SAFETY EVALUATION BY THE OFFICE OF NUCLEAR REACTOR REGULATION

SAN ONOFRE NUCLEAR GENERATING STATION UNIT NO. 1

INTAKE STRUCTURE

FIGURE 4

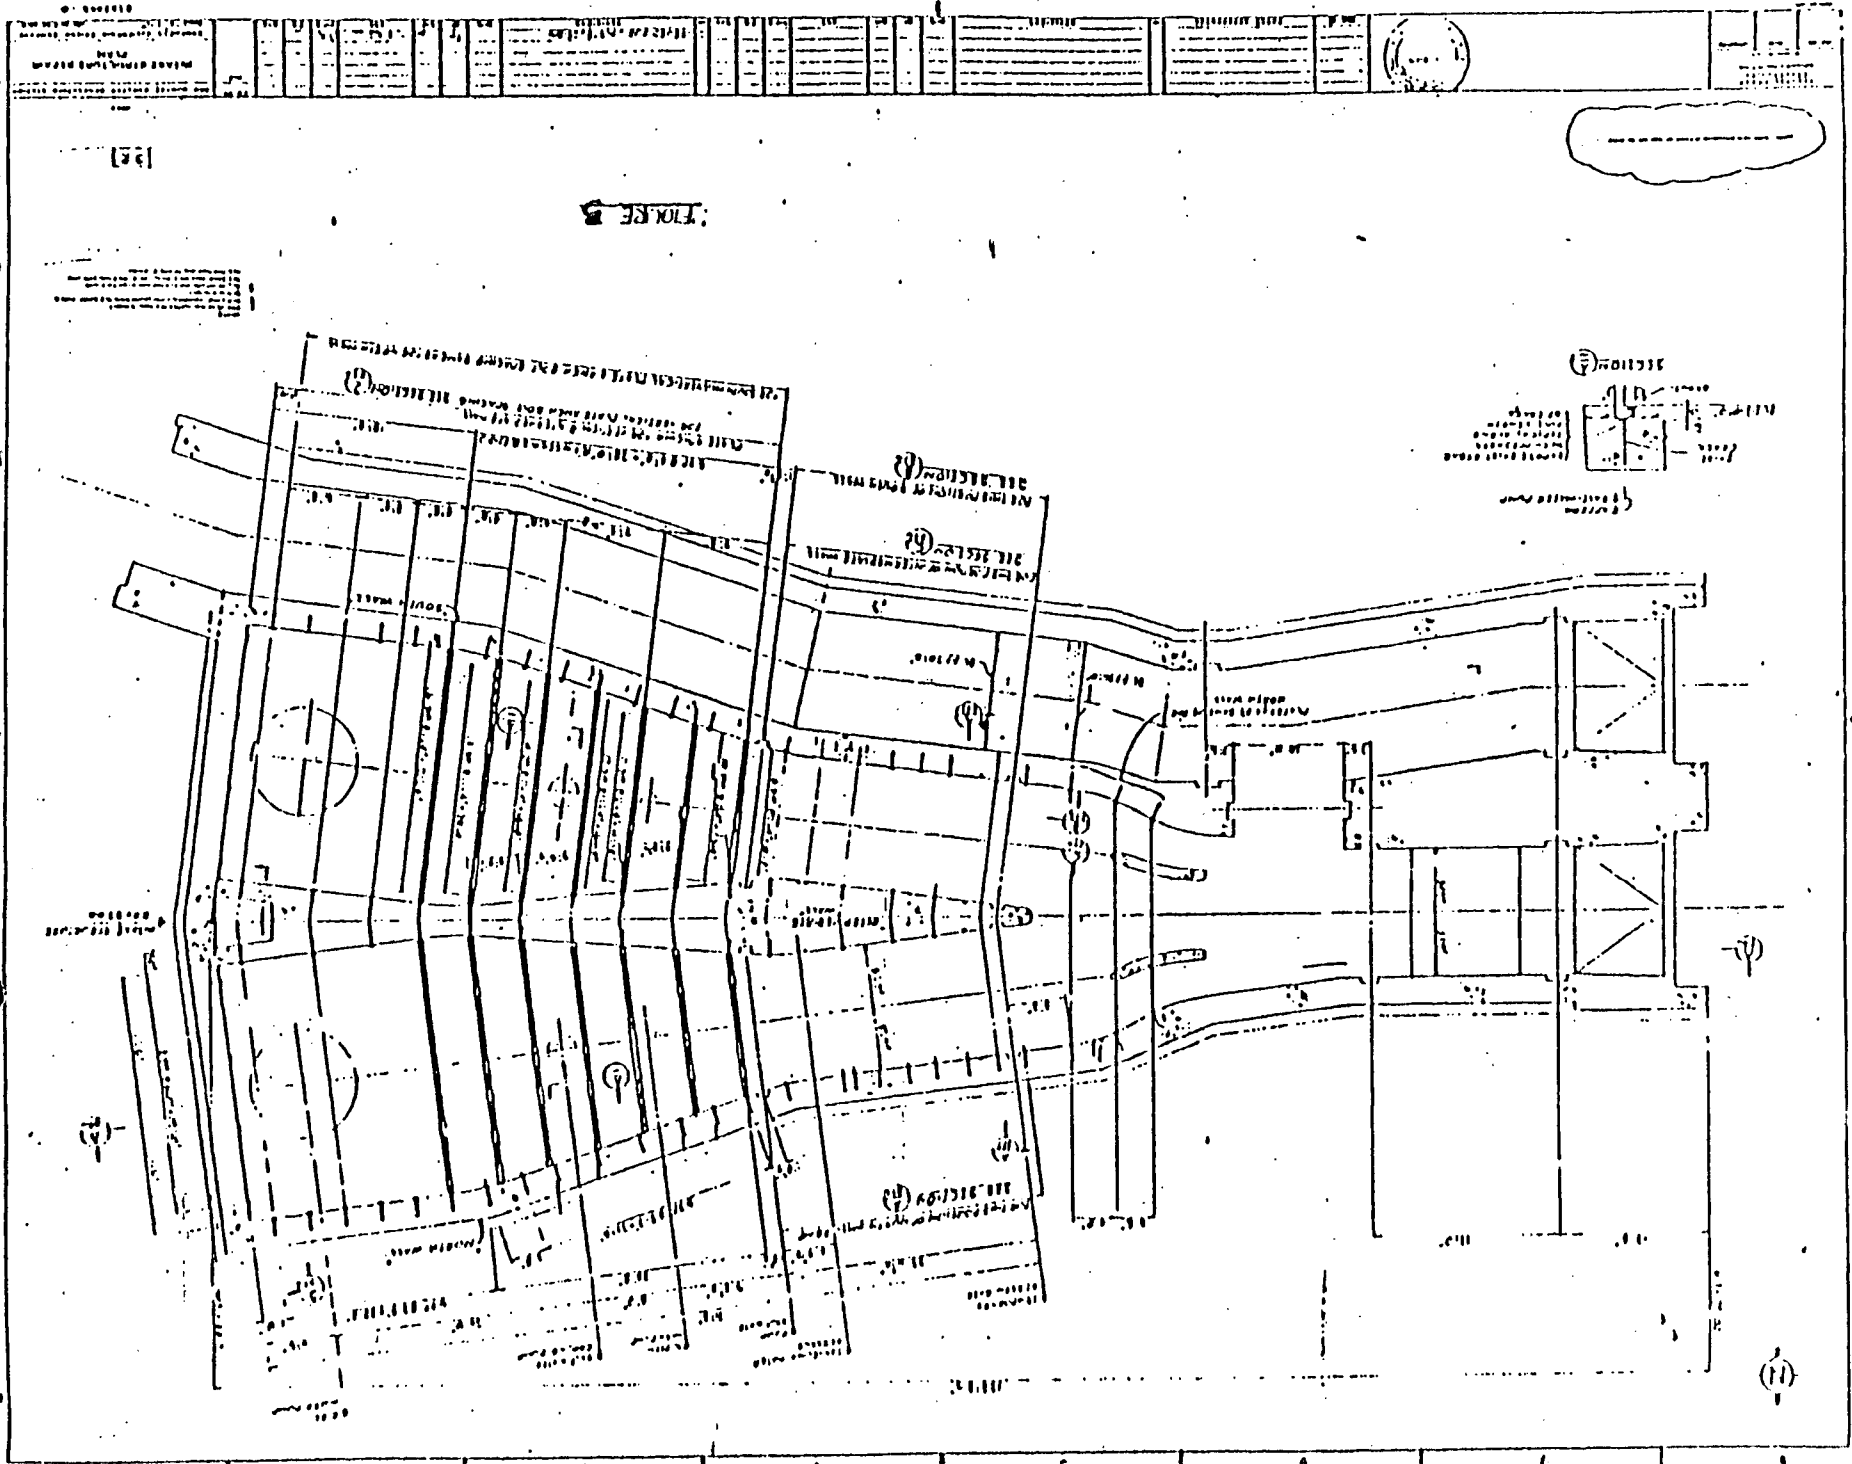
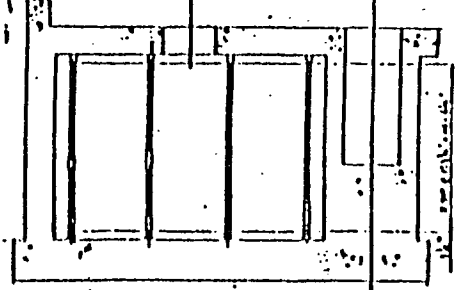
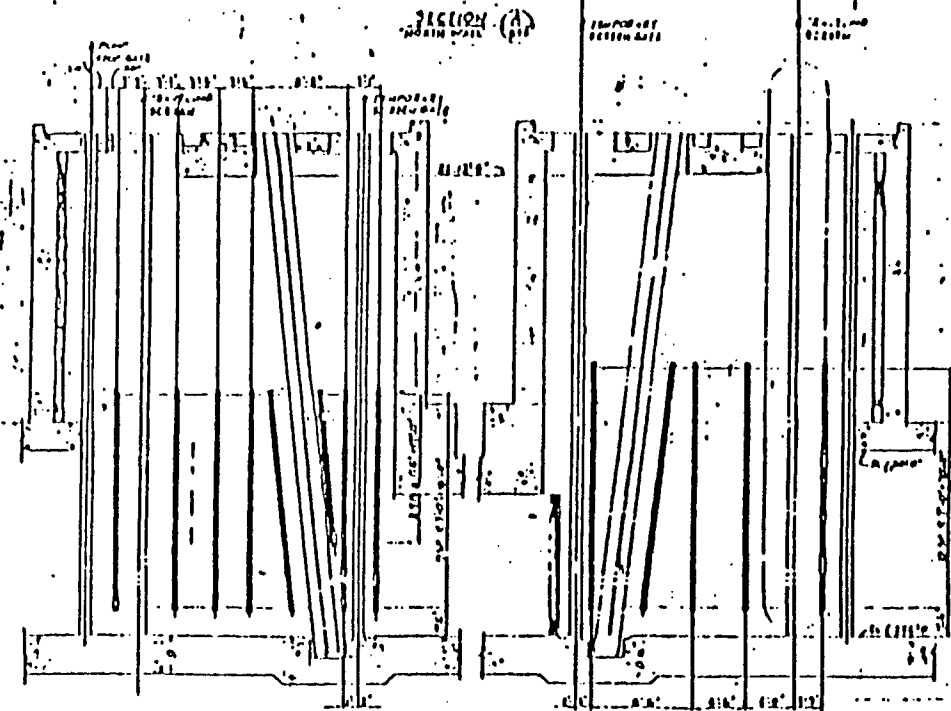
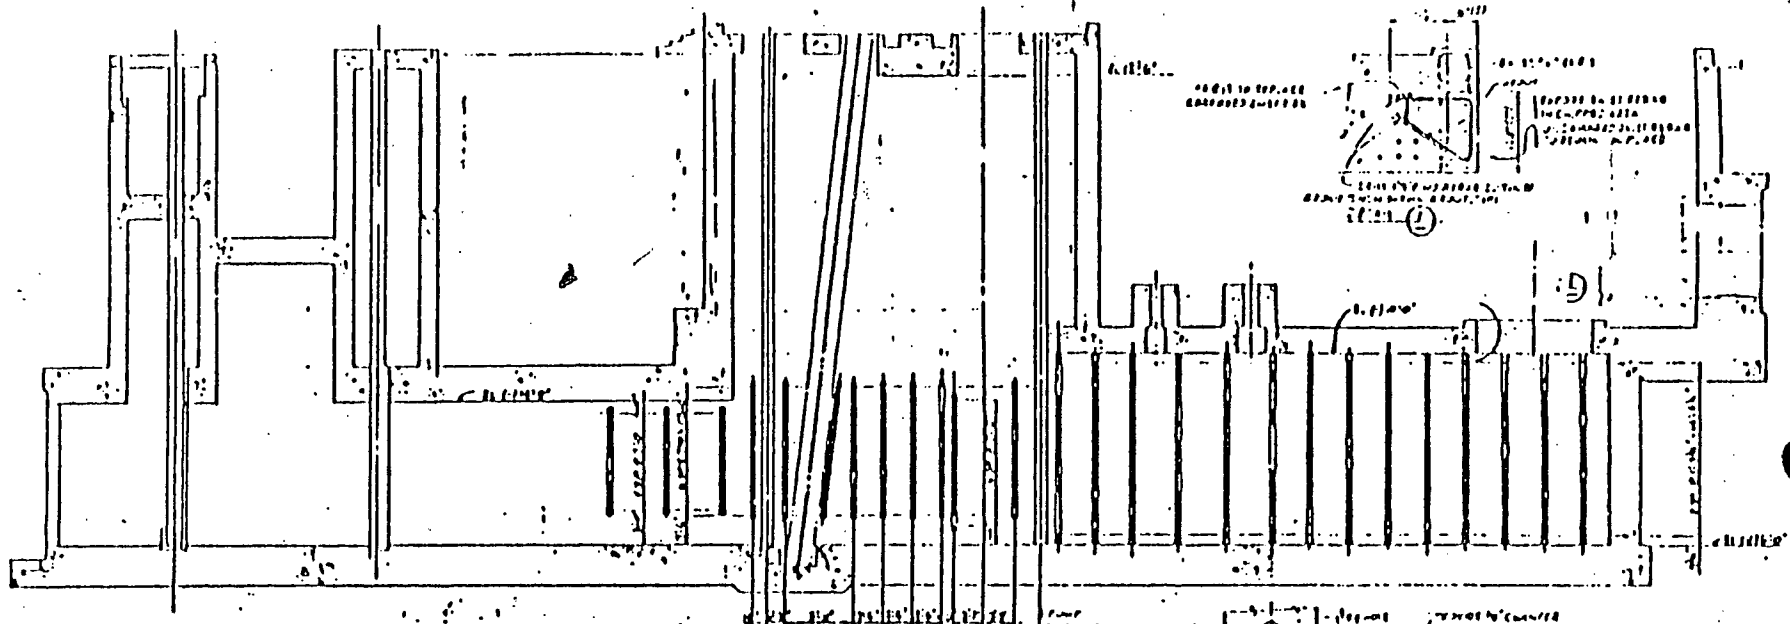
The walls and slab of the pump well and lower screen well area were strap plated with carbon steel plate strips coated with a coal tar epoxy coating to protect them from corrosion (See Figs. 3 and 4). Sacrificial anodes were added to provide additional protection. Monel anchor bolts were fabricated from corrosion resistant material such as ASTM B-164 and were grouted in-place. The delaminated 3 to 4 inches of concrete was left in place and is kept in place by pretensioning the strap anchor bolts to generate compression on the delaminated interface.

The above described strap plates were designed to resist maximum tensile stress which would develop at the inside face under the design loads. A composite action was assumed between existing concrete and strap. The composite actions between the concrete and strap was assured by designing monel anchor bolts to be shear connectors and by grouting and preloading them. The design of anchor bolts was checked by both American Concrete Institute shear friction methodology and AISC shear connectors design. The straps were not preloaded by the forced displacement of walls prior to plate installation.

- ° The licensee's use of the steel straps to restore the function of the inside reinforcement is adequate. The composite action between the strap and concrete is designed on a sound basis using two separate codes.
